Attachment C

Re: Objection to Development Applications D/2020/1387/C & D/2015/661/D – 410 Pitt Street, Haymarket

- **D/2020/1387/C** Section 4.55(2) modification of the existing consent for a new Hotel, and
- **D/2015/661/D** Section 4.55(2) modification to amend the approved concept building envelope to reflect an amended design for the lift overrun, increasing the approved height of the lift overrun and concrete housed tuned sloshing damper by 1.9m from RL 121.110 (AHD) to RL123.100 (AHD)

Figure 2 – Proposed extra 2m in height (pink) would have devastating daylight /ambient light and view loss for the upper levels of Miramar

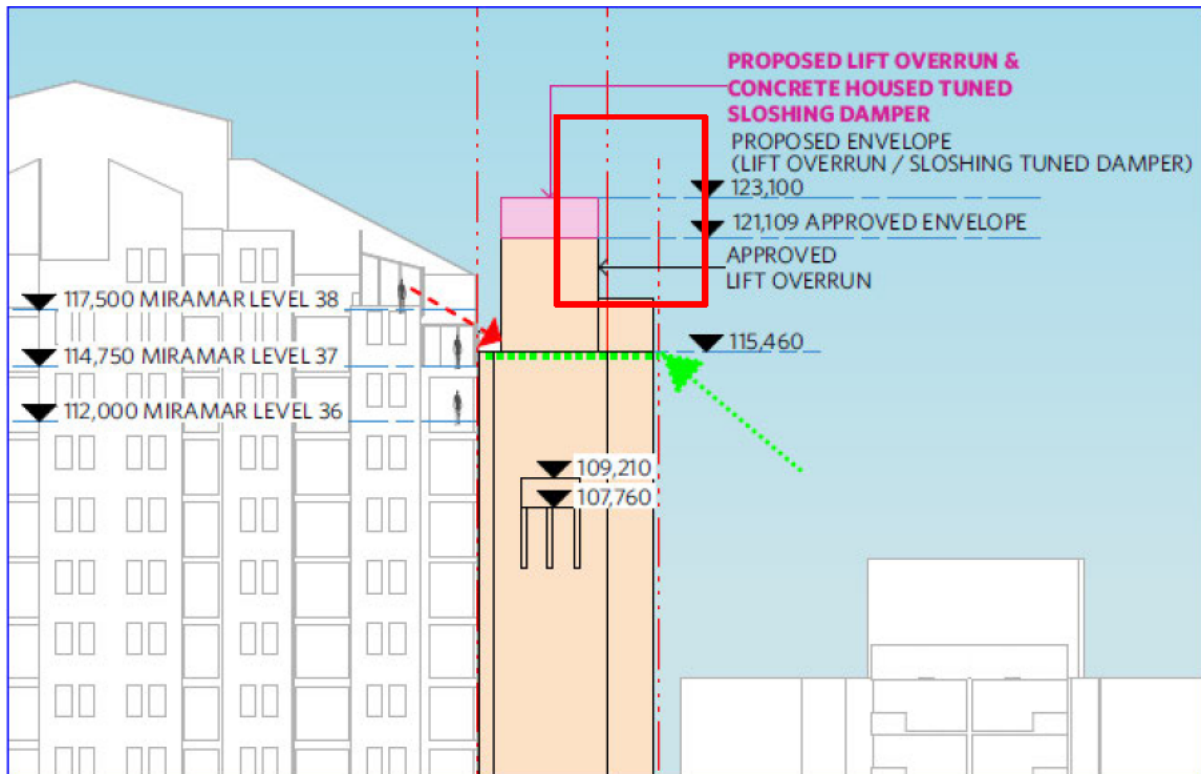
The current S4.55 DAs now propose to further increase to the approved envelope i.e. an **additional 2m** (from RL 121.110 to RL 123.100 to) will completely wipe out the remaining views for the upper level neighbours e.g. Apartment 262 on Level 37 and any remnant access to daylight or ambient light to their primary living areas (lounge room, kitchen, winter garden and balcony).

The green dashed-line and arrow in Figure 1 above indicates the Court's ruling in the original 2015 DA approval. This site has already "back-flipped" once on its undertaking to Commissioner Susan O'Neill and the Court, to not further increase the original approved-height of RL 115.46.

The S4.55's proposed new RL of 123.100 represents a **7.64m** increase (from the original Court-approved height of RL 115.460), and the proposed new envelope would result in complete/total and devastating view loss and loss of daylight for Apartment 262 – see Headings 5.1 & 5.2 for more details.

Figure 6 – Key to locations of Pictures 1, 2 & 3

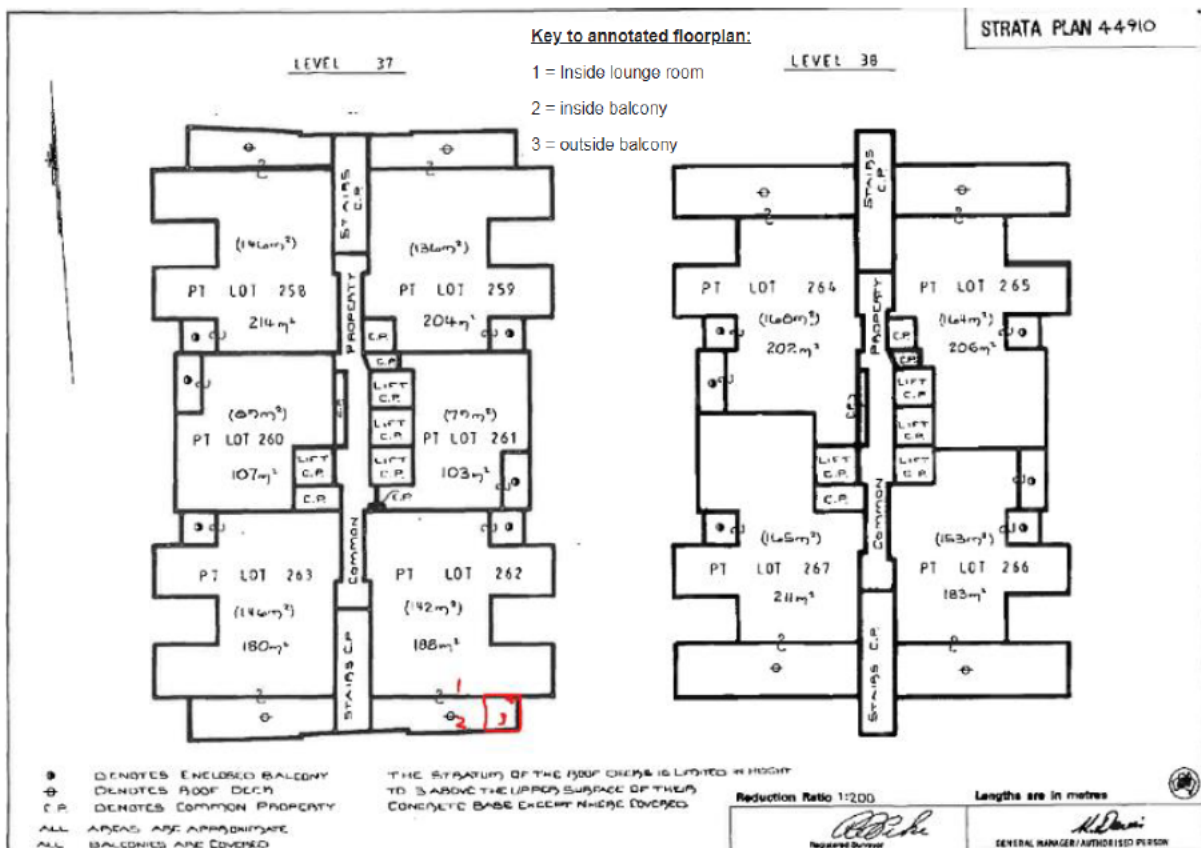
Applying the above principles to the adjoining Miramar residences, it is considered that the existing view to the State heritage-listed Central Railway Station (and its clock tower), Belmore Park and distant views to land-water interface of Botany Bay as highly iconic and what most people would describe as wonderful/desirable. Refer to existing view photographs (Figures 3, 4 and 5) below for more details.

However, only 1 view/vantage point (from within Unit 262’s living room looking out to the winter garden) has been provided for analysis. It is critical that Council require a comprehensive *View Sharing Analysis (VIA)* to be provided from several additional view/vantage points, per on-site discussion with Adrian McKeown Council Senior Town Planner:

- within the winter garden (centre)
- within the winter garden (left/east side)
- within the outdoor balcony (east)

Analysis from several additional view/vantage points is required to clearly depict the magnitude of view loss impact of the proposed S4.55 development.
